SYDNEY CENTRAL CITY PLANNING PANEL

COUNCIL ASSESSMENT REPORT

Panel Reference	PPSSCC-44
DA Number	DA/646/2019
LGA	City of Parramatta (formerly Hornsby Shire Council)
Proposed Development	16 storey mixed use seniors living tower comprising 14 assisted living apartments, 20 care apartments, 60-bed residential aged care facility, 96 independent seniors living units and ancillary offices/retail; 155 car parking spaces in 4 basement levels; signage zones; landscaping; site amalgamation; public domain works; demolition of existing buildings and tree removal. This seniors living development is proposed pursuant to State Environmental Planning Policy (Housing for Seniors or People with a Disability) 2004.
Street Address	43 - 53 Oxford Street, EPPING NSW 2121 (Lots 1-3 & 5 DP18447, Lots A & B DP357452)
Applicant	G M Fielden
Owner	Uniting Church In Australia - Epping
Date of DA lodgement	12 November 2019
Number of Submissions	44
Recommendation	Approval
Regional Development Criteria	The development has a capital investment value of more than \$30 million.

Figure 10. Proposed breach of height limit in context of approved/existing development in the vicinity (red line represents height standard).

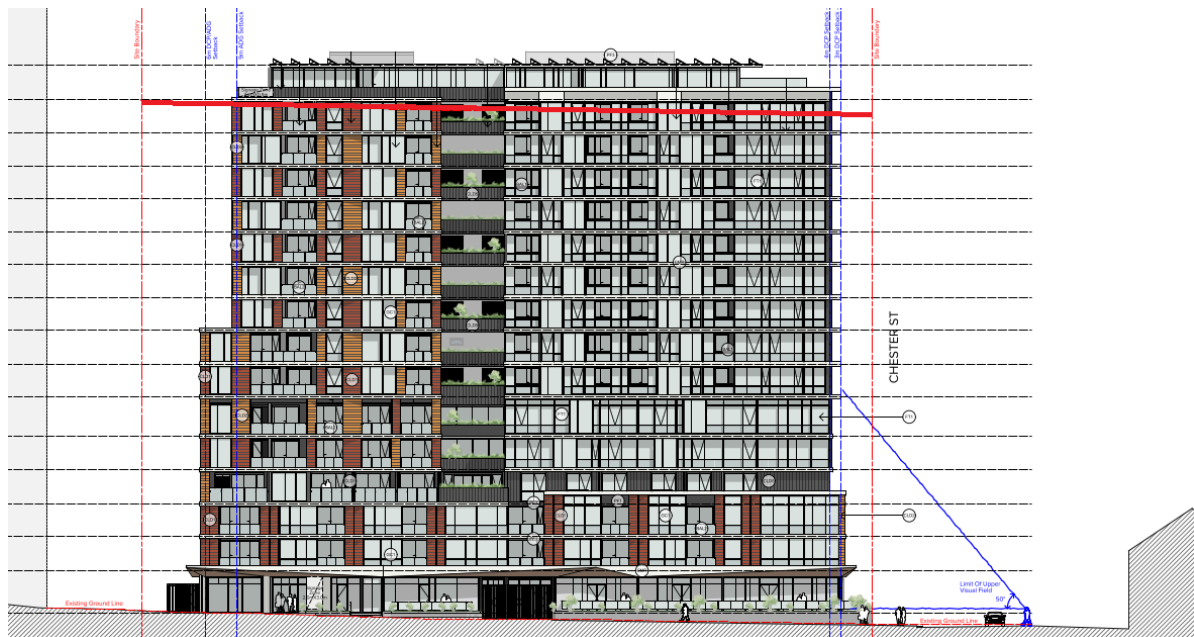
The proposal does not comply with the Clause 4.3 ‘Height of Buildings’ development standard, as outlined in the table above and figure below, and as such the applicant has submitted a request to vary the height standard under Clause 4.6 of the HLEP 2013.
